Access Compliance Report

Public Rights-of-Way

Intersection ID: 26100	Main Street: FAIRCHILD_LN	Cross Street: HOLLY_HILL_FARM_RD	Location: SE
ADA ID: 801DD9B9AD67	Ramp Type: PerpDiag	Initial Pass/Fail: Fail	Overall Compliance: No
Severity Score: 37.5			
Codes/Mitigation Info/Possible Solution		Field Measurements/Component Compliance

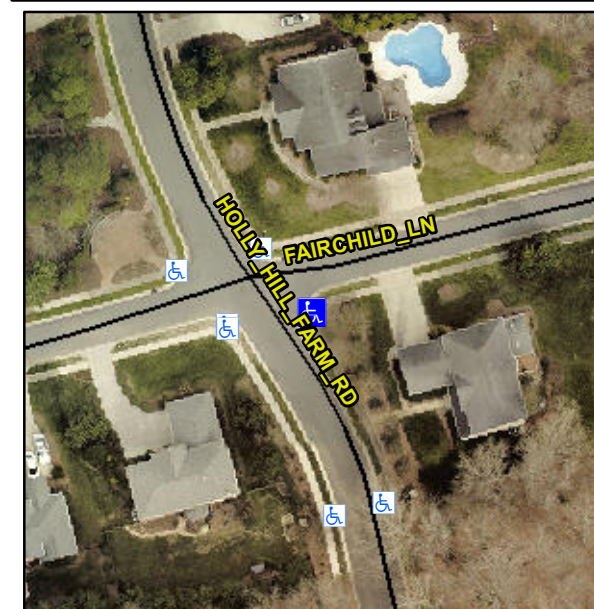
R304.2.2, R304.5.3

Compliance	Description	Data	Compliance	Description	Data
N/A	Ramp Length (in)	48.0	No	Ramp Slope (%)	10.1
Yes	Ramp Width (in)	49.0	No	Ramp XSlope (%)	8.1
N/A	Flare Type LT	N/A	N/A	Flare Type RT	N/A
N/A	Flare Slope LT (%)	N/A	N/A	Flare Slope RT (%)	N/A
N/A	Flare Traversable LT?	N/A	N/A	Flare Traversable RT?	N/A
N/A	Landing Length (in)	N/A	N/A	DWS Provided?	N/A
N/A	Landing Width (in)	N/A	N/A	DWS Contrast?	N/A
N/A	Landing Slope (%)	N/A	N/A	DWS Length (in)	N/A
N/A	Landing X Slope (%)	N/A	N/A	DWS Full Width?	N/A
N/A	Landing Curb? (Y/N)	N/A	N/A	DWS Offset (in)	N/A
N/A	Shared Landing?	N/A			
N/A	Gutter Ponding?	N/A	N/A	Gutter Slope (%)	N/A
N/A	Gutter Lip Ht (in)	N/A	N/A	Gutter X Slope (%)	N/A
N/A	Painted X Walk1?	No	N/A	Painted X Walk2?	No
	X Walk 1 Direction	To NW		X Walk 2 Direction	To W
N/A	X Walk 1 Width (in)	N/A	N/A	X Walk 2 Width (in)	N/A
	X Walk 1 Slope (%)	0.4		X Walk 2 Slope (%)	6.0
	X Walk 1 X Slope (%)	6.1		X Walk 2 X Slope (%)	1.1

Remove & Replace Curb Ramp With Two New Directional Ramps or Equivalent.
